## DESCRIPTIVE REPORT

*Registry No.* ..... H11610

*General Locality* ..... Approaches to Cordova, Alaska

## Revision compiled during office processing and certification

Figure 4: Roll artifacts south of Hells Hole

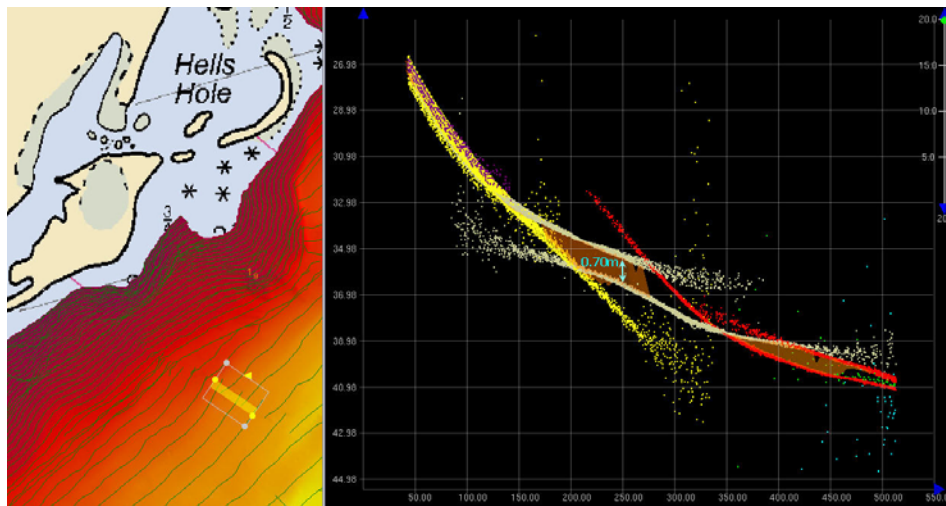
As mentioned in the *DAPR*, roll issues were found to be present in some of the MBES data collected from launches 1018 and 1010. Roll issues were found in survey H11610 during all days of data acquired by launch 1018 (DN 267, 268, 270, 277, 290), which were caused by the swing arm transducer mount. To help eliminate roll issues, Fairweather personnel evaluated and adjusted daily HVF files using adjacent lines for the aforementioned days when roll errors were present. After adjustments to the HVF were made, most data met accuracy specifications as stated within the *HSSDM*, with some roll artifacts still present south of Hells Hole (see *Figure 4*).<sup>9</sup>

<sup>9</sup> Concur with clarification, Data from launches 1010 and 1018 was edited due to the roll error. The HVF files did not match the values documented in DAPR.

Figure 3.1.1

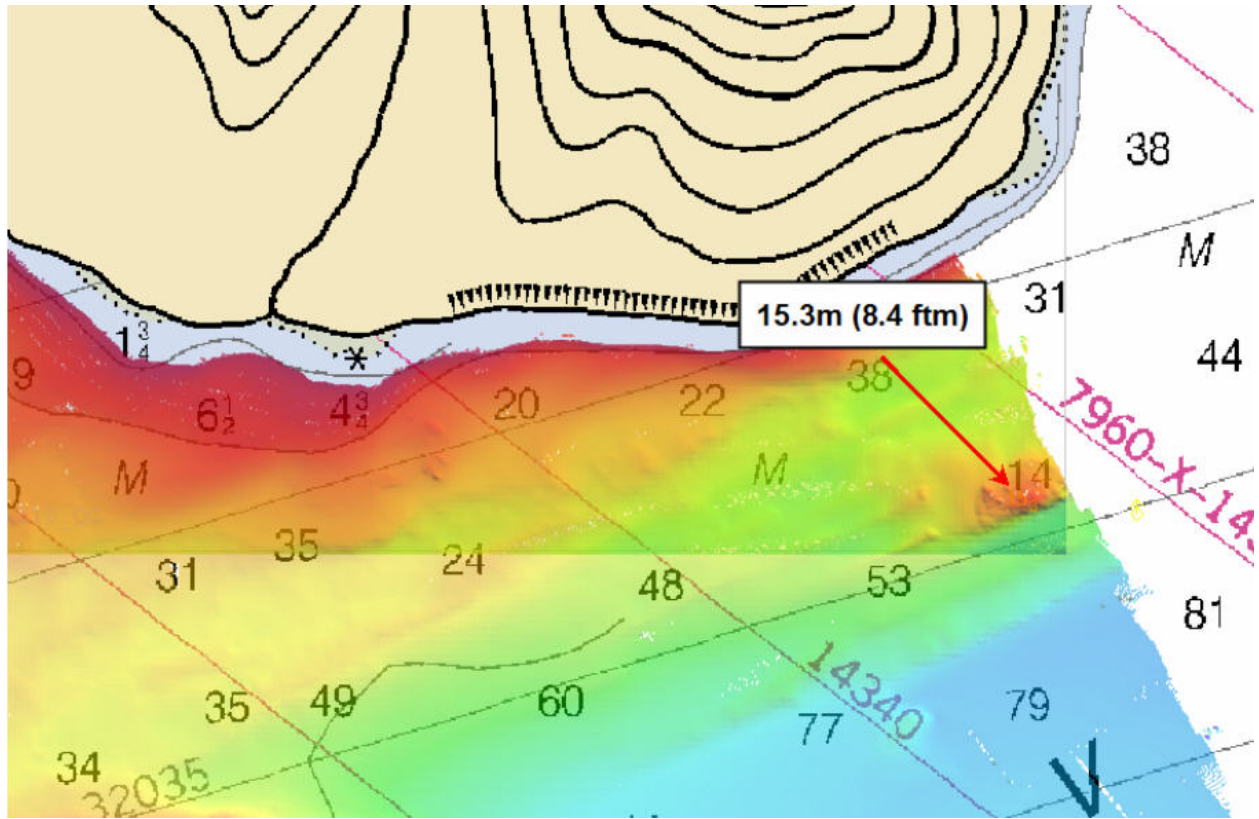
The Hydrographer recommends removing the 14 fathom sounding from chart 16708 and adding an 8-1/4 fathom obstruction (Chart 1 - K.41) in the measured location.

Concur with clarification. Chart 8 fathom 2 foot sounding.

Figure 3.2.1

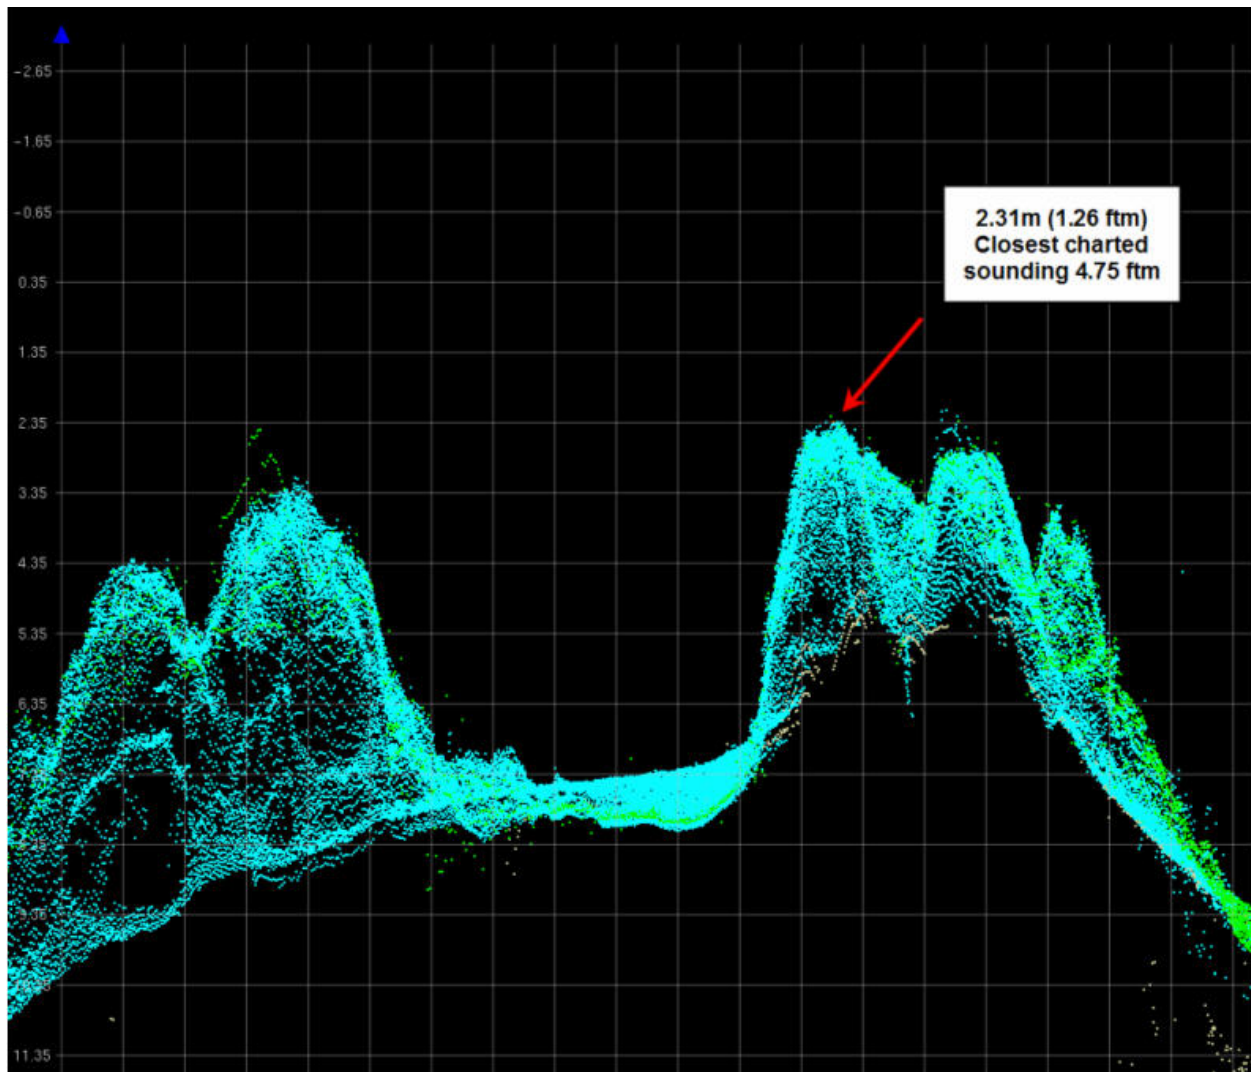
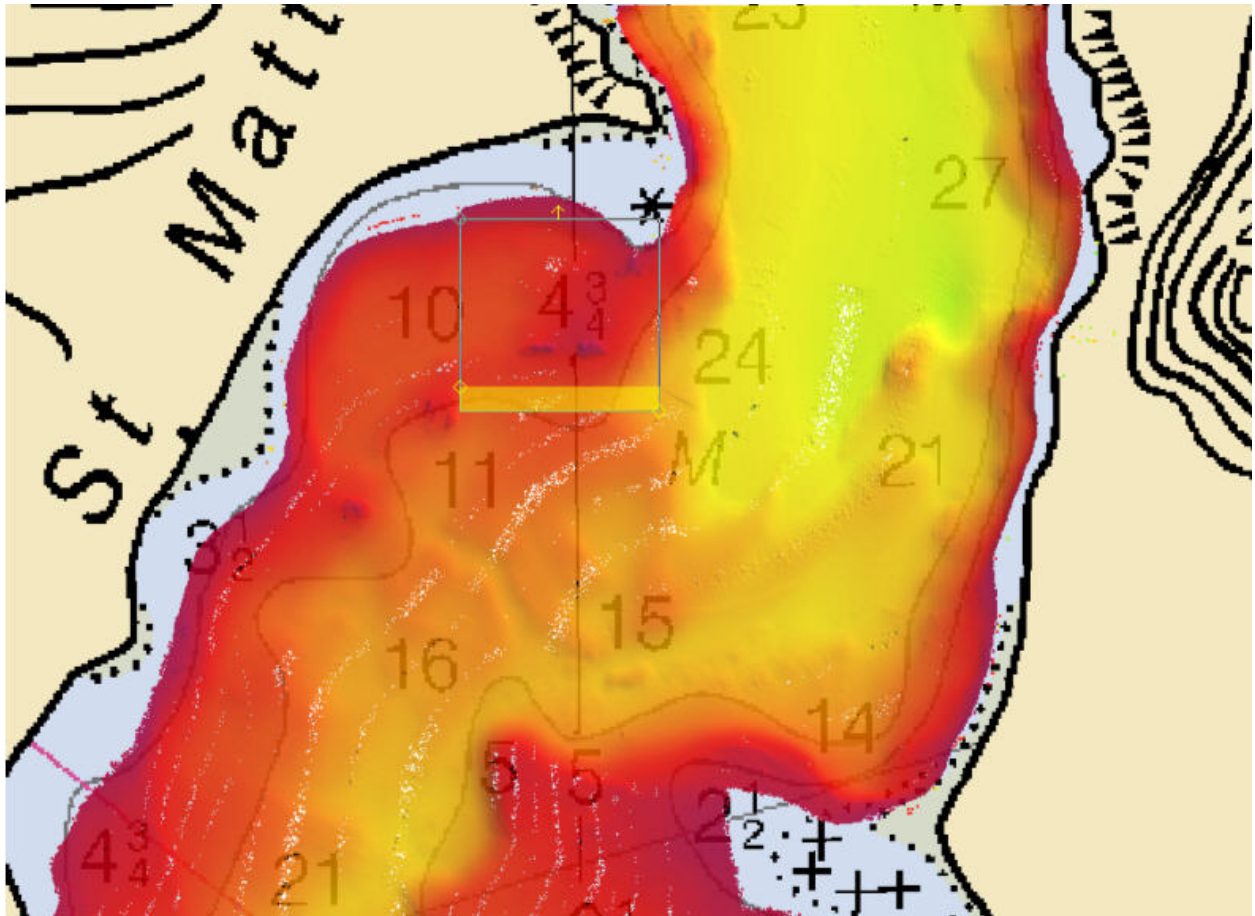
The Hydrographer recommends removing the 4-3/4 fathom sounding from chart 16708 and adding an 1-1/4 fathom sounding in the measured location.

Concur with clarification. Chart 1 fathom 1 foot sounding.

Figure 3.3.1

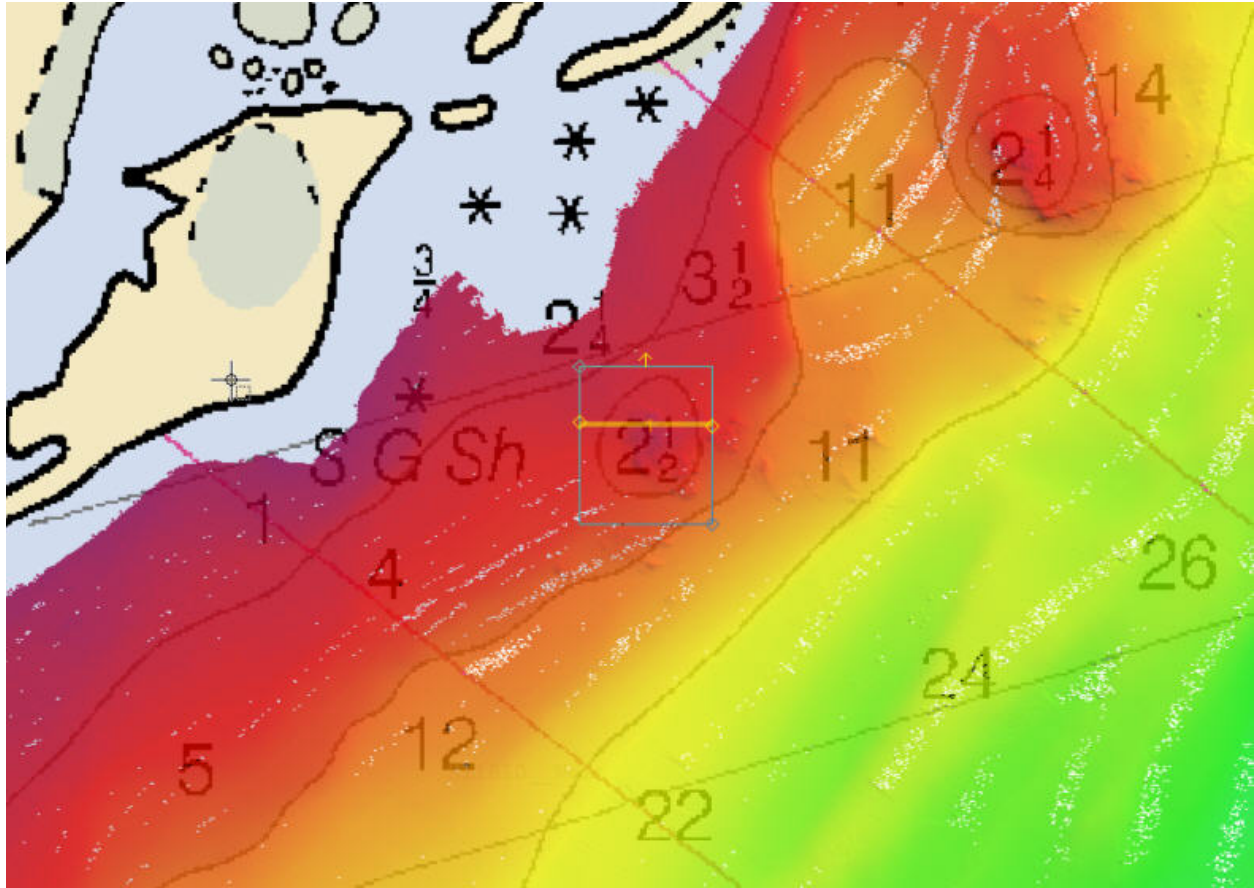
The Hydrographer recommends removing the 2-1/2 fathom sounding from charts 16708/16709 and adding 1 fathom sounding in the measured location.

Concur with clarification. Chart 2 fathom 4 foot sounding.

Figure 3.4.1

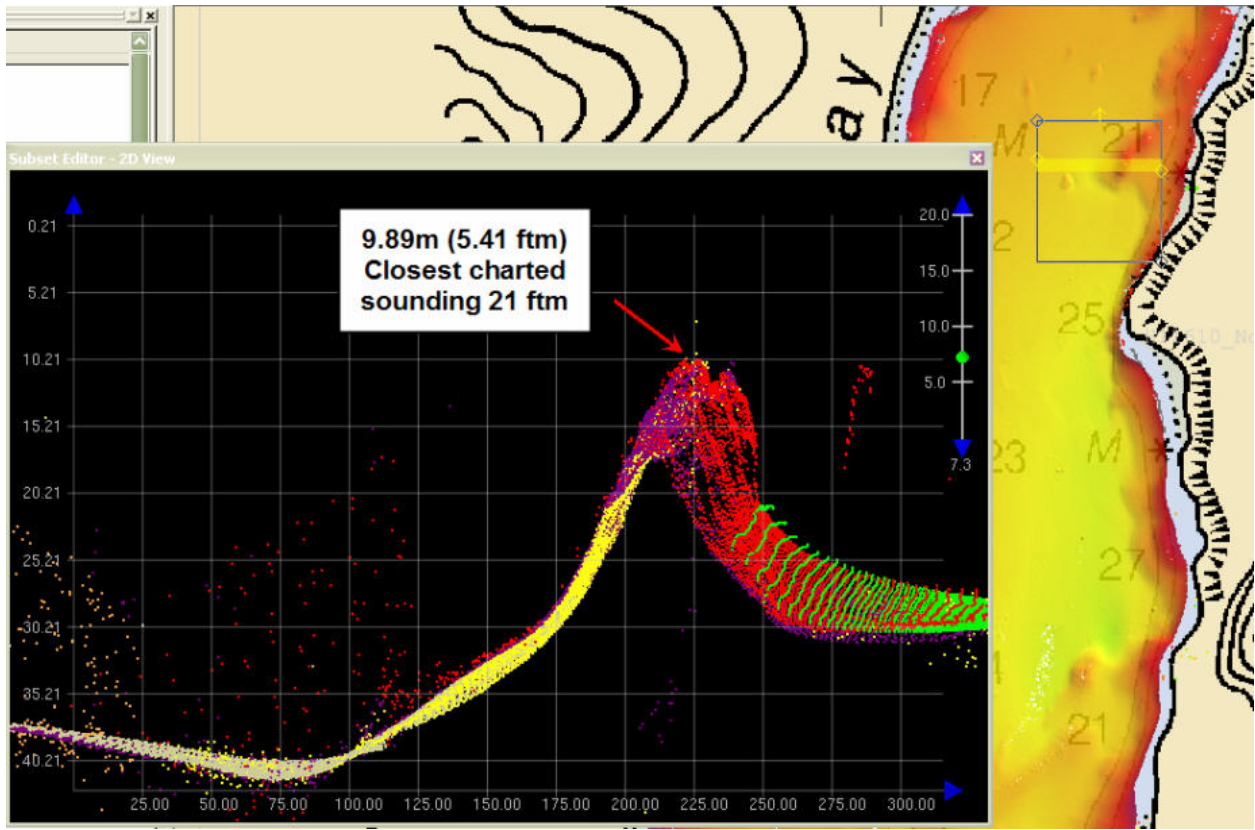
The Hydrographer recommends removing the 21 fathom sounding from chart 16708 and adding a 5-1/4 obstruction (Chart 1 - K.41) in the measured location.

Concur with clarification. Chart 5 fathom 2 foot sounding.

Figure 3.5.1

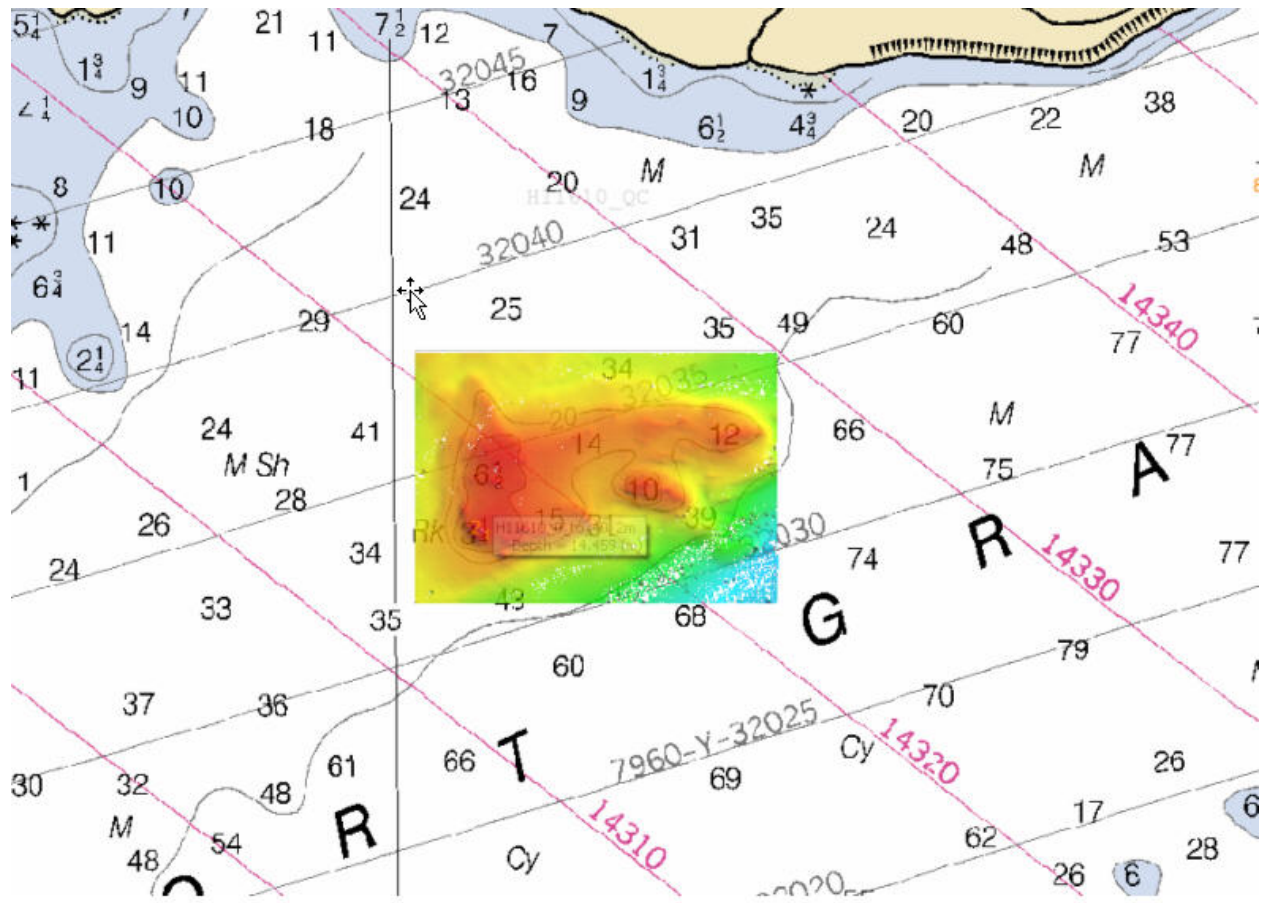
The Hydrographer recommends removing the 3-1/4 fathom sounding from charts 16708/16709 and adding a 2-1/4 fathom sounding in the measured location.

Concur with clarification. Chart 2 fathom sounding.
